SUFFOLK DOWNS REDEVELOPMENT

Supplemental Information Document

MAY 1, 2019

SUBMITTED TO
Boston Planning &
Development Agency

Figure 1.15
Rt 1A Entrance Plan Comparison

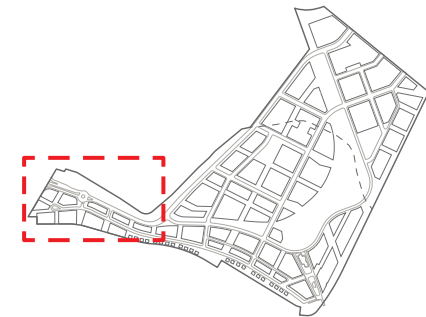
Figure 1.15 illustrates the re-designed Route 1A entrance that is more urban in nature compared to the “jug-handle” option. This design alternative enables an intersection closer to Route 1A; however, due to limited access for the buildings right against Route 1A, there is still a need for a cul-de-sac.

As shown on the Rt 1A entrance plan, Figure 1.15, the secondary street parallel to Waldemar Ave has been shifted and the length of cul-de-sac has been reduced with a connection at a roundabout on the entrance road (which has also been shifted slightly). This provides a plan where the buildings on either side of the new road are more similar in plan. The buildings on the south side adjacent to the Orient Heights neighborhood will be lower in scale in keeping with the heights in the agreed zoning revision, while the buildings to the north flanking the entrance drive will be taller in keeping with their prominence in creating an "urban entrance" statement at Rt 1A.

Figure 2.1
Tomasello - Parkway Intersection Plan Comparison

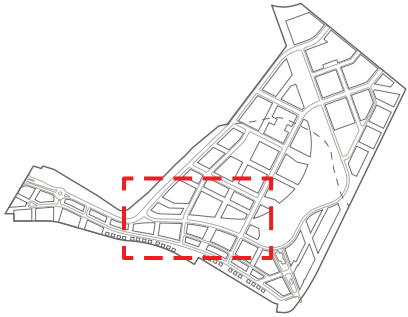
As shown in Figure 2.1, based on the BPDA comments the view corridor at the intersection of Tomasello Drive and Parkway has been widened to create a sense of arrival and a landmark

Figure 2.3
Proposed Lobby Location Plan

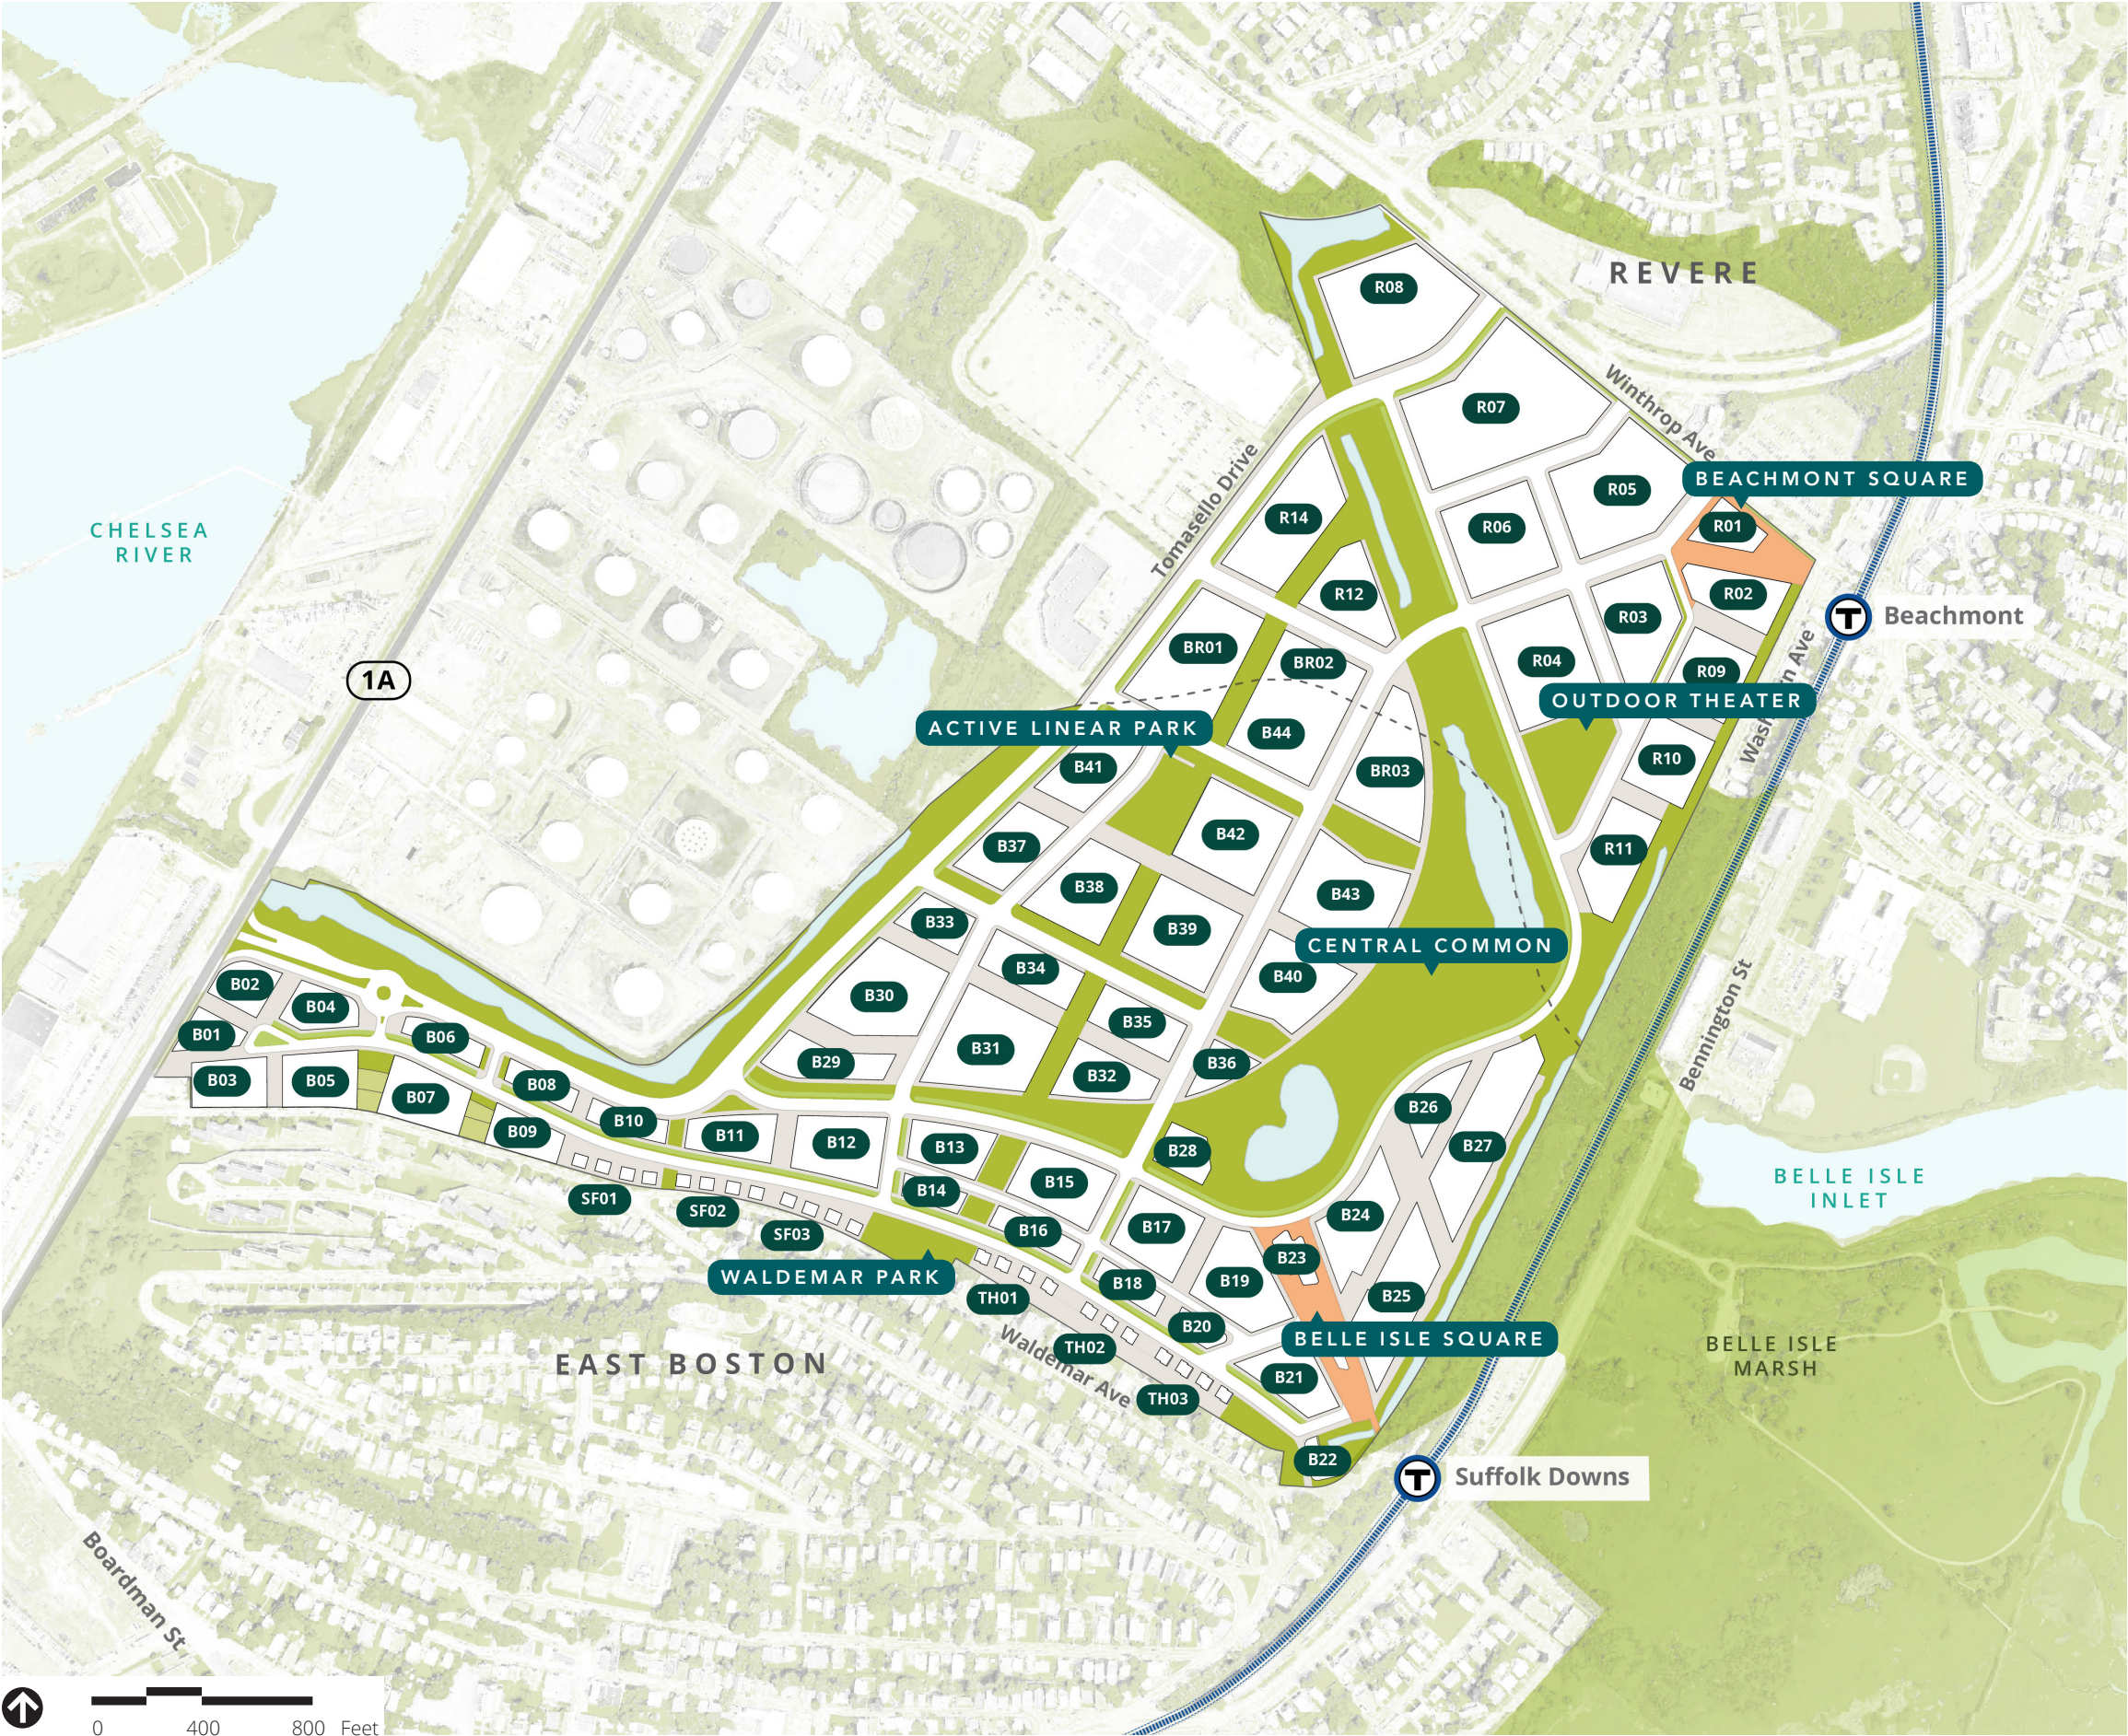
The service and loading diagram provided as Figure 2.2 and lobby diagram provided as Figure 2.3, demonstrate that loading occurs on secondary and tertiary streets avoiding the proposed commercial spine of Main Street and other major streets, such as the Park Road and Tomasello Drive. Future building design relative to the location of building entrances, ground floor porosity, and activation of key streets and open spaces will be subject to review and comment during the Development Review Process outlined in the draft PDA Documents (Appendix A).

The service and loading diagram provided as Figure 2.2 and lobby diagram provided as Figure 2.3, demonstrate that loading occurs on secondary and tertiary streets avoiding the proposed commercial spine of Main Street and other major streets, such as Tomasello Drive. Future building design relative to the location of building entrances, ground floor porosity, and activation of key streets and open spaces will be subject to review and comment during the Development Review Process outlined in the draft PDA Documents (accessible via the web links provided in Appendix A).

Figure 2.5
Waldemar Grading Plan

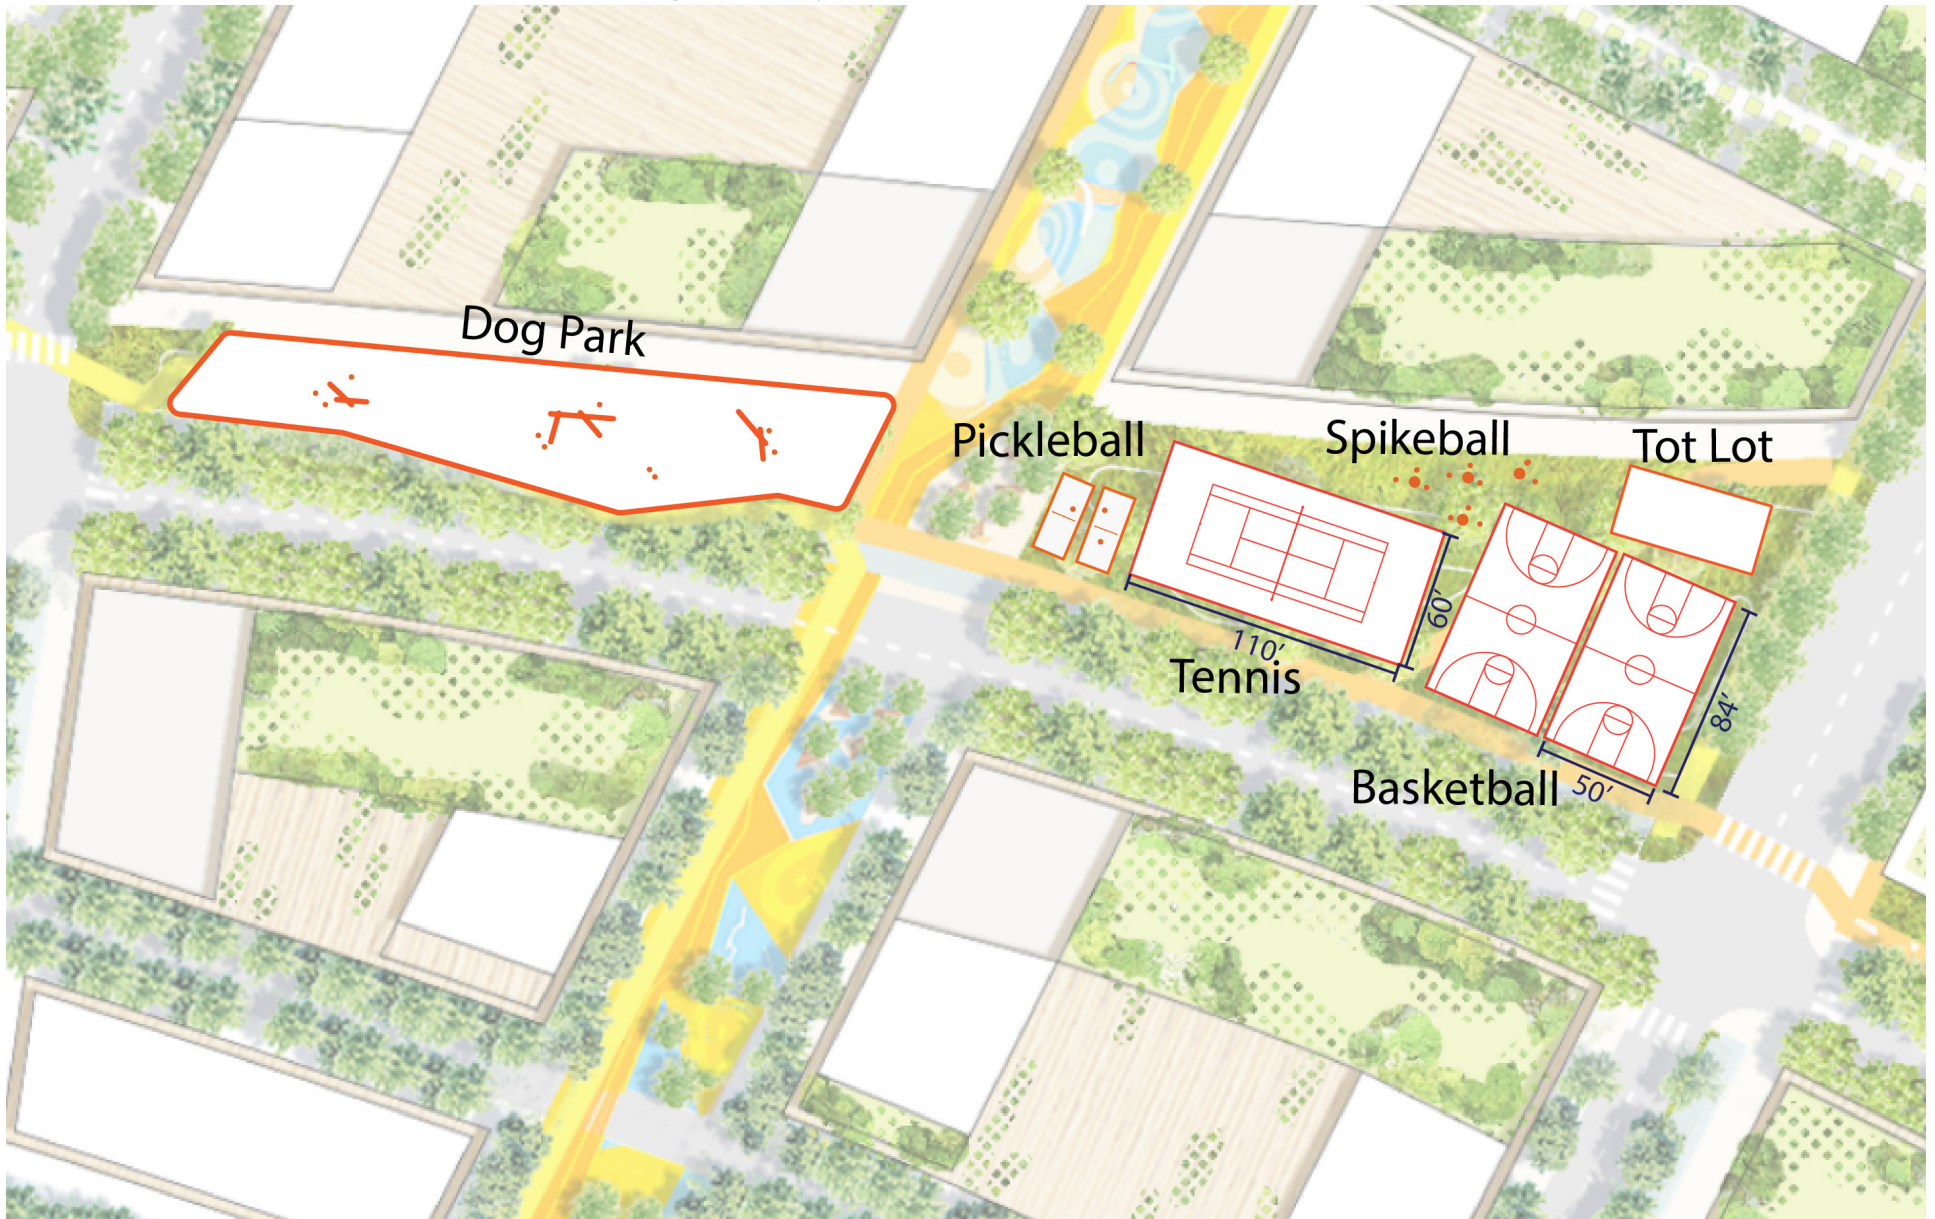
As shown in Figure 2.5, the Proponent has added an urban wild landscape buffer area between the single-family residences and Block 4. Beyond Block 4 is the proposed pedestrian connection and urban staircase which aligns with the BHA's Orient Heights redevelopment. Additionally, the new Waldemar Avenue park also provide a pedestrian and bicycle connection from Waldemar Avenue/Orient Heights neighborhood to the Project Site and its 40-acre open space system. Both proposed pedestrian connections will be ADA accessible connections.

Gateway Park Detail Plan

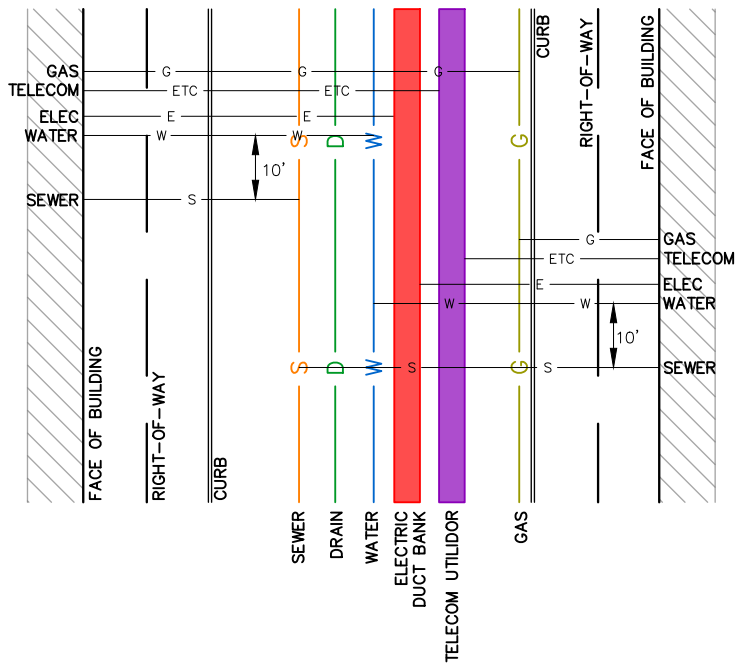
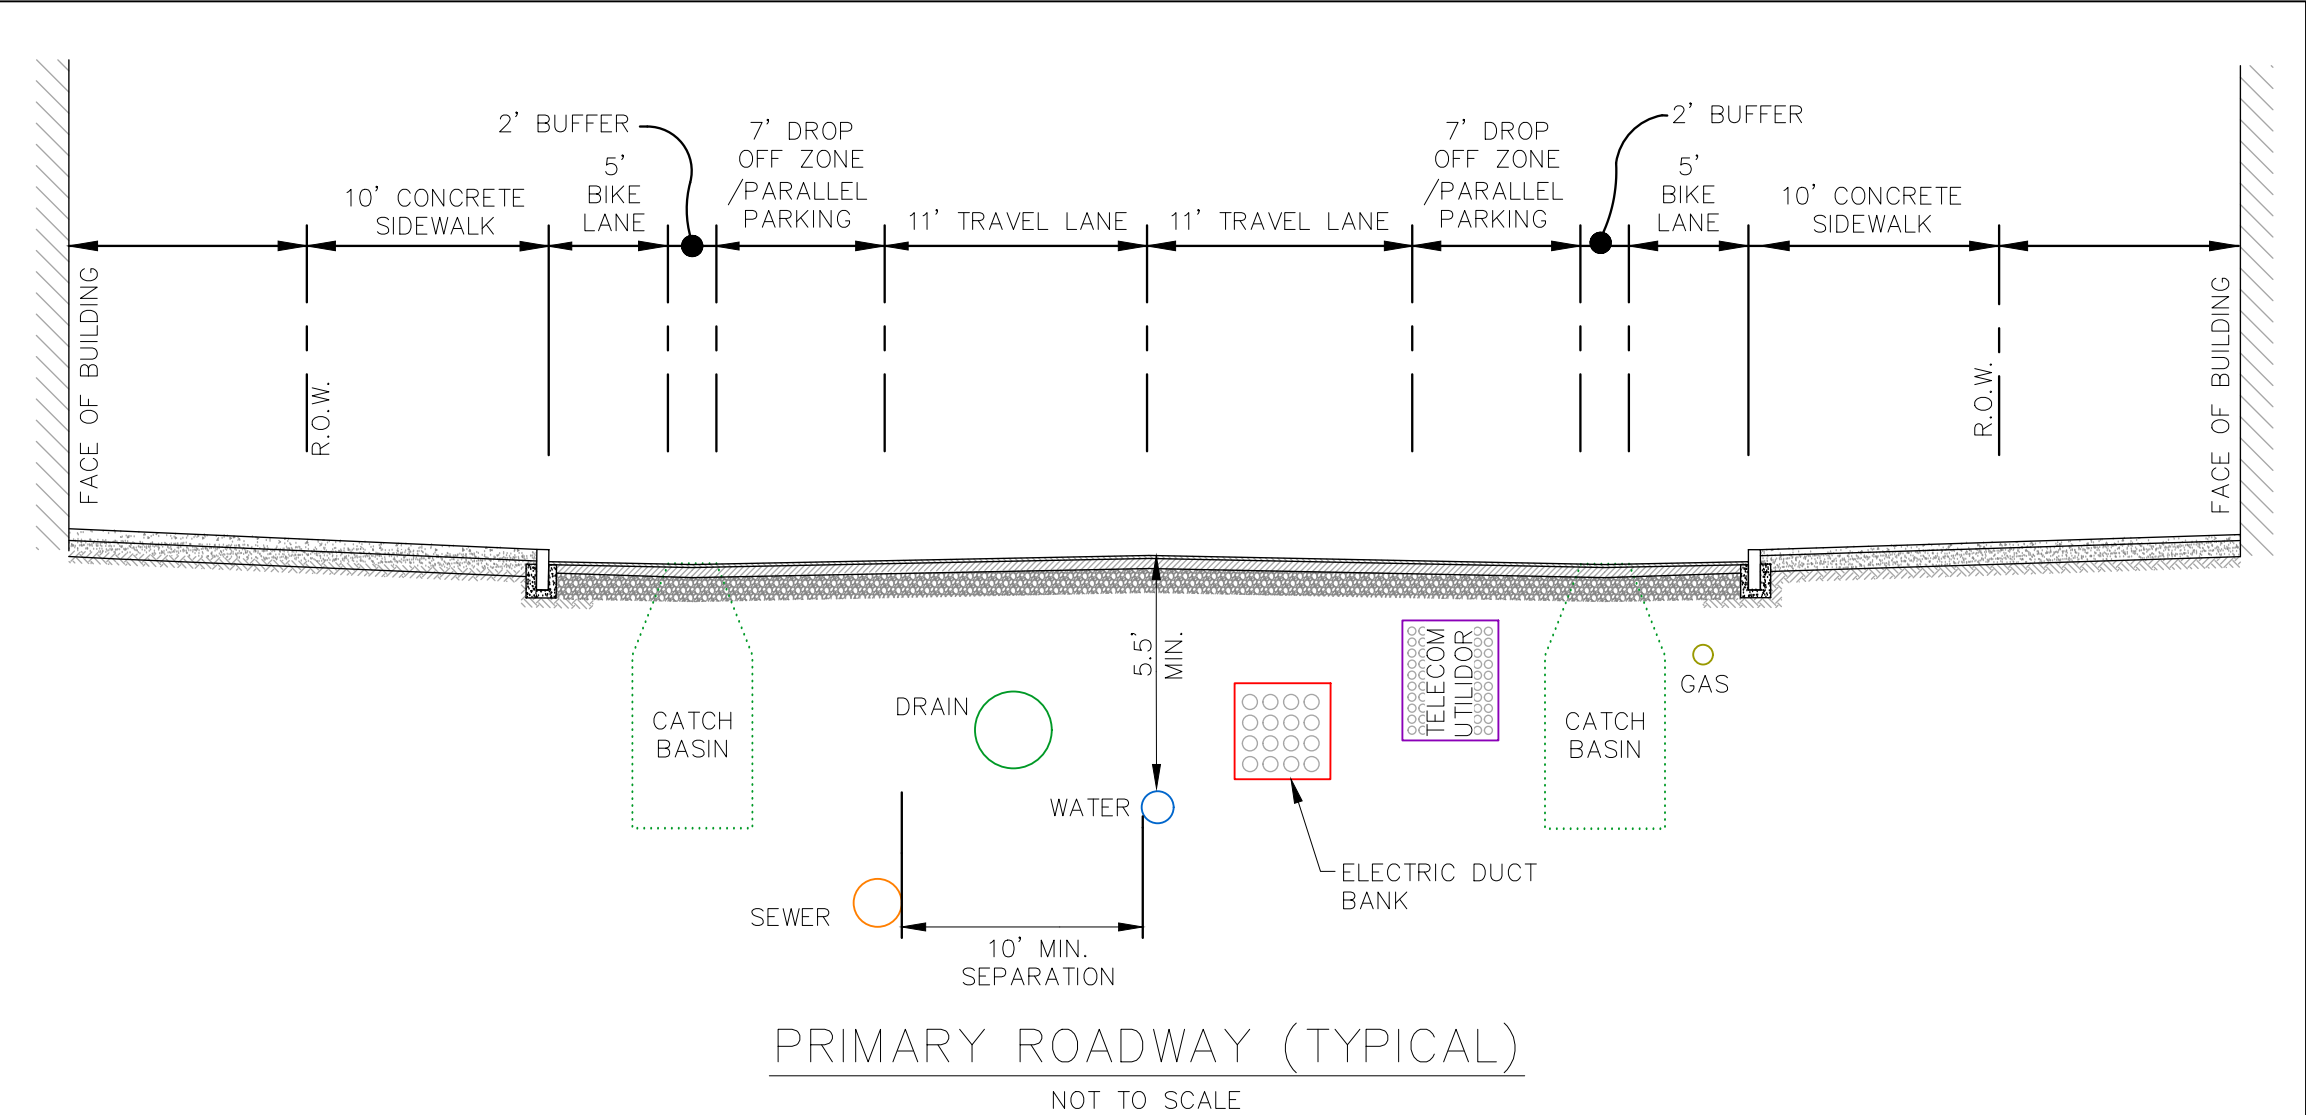
The Proponent has studied the space adjacent to blocks 26, 28, and 30 (previously indicated as 17, 19, and 20) and proposes improvements as shown in Figure 2.6. At the narrow end of the Parkway the open space is to be developed as a Dog Park with a tree shaded pedestrian sidewalk adjacent to these three buildings; the rain capture space forms a generous median between this park usage and the more active community path and cycle track. At the wider end of the Parkway the cycle track and community path are moved more toward the center and the right of way is widened to allow the retention swale to be located between these and the roadway. Working with Boston Parks and Recreation Department, delineated active court sport facilities will be developed in the open space with planting adjacent to both sides of the path and cycle track. This development creates an active recreational "gateway park" for the Master Plan Project.
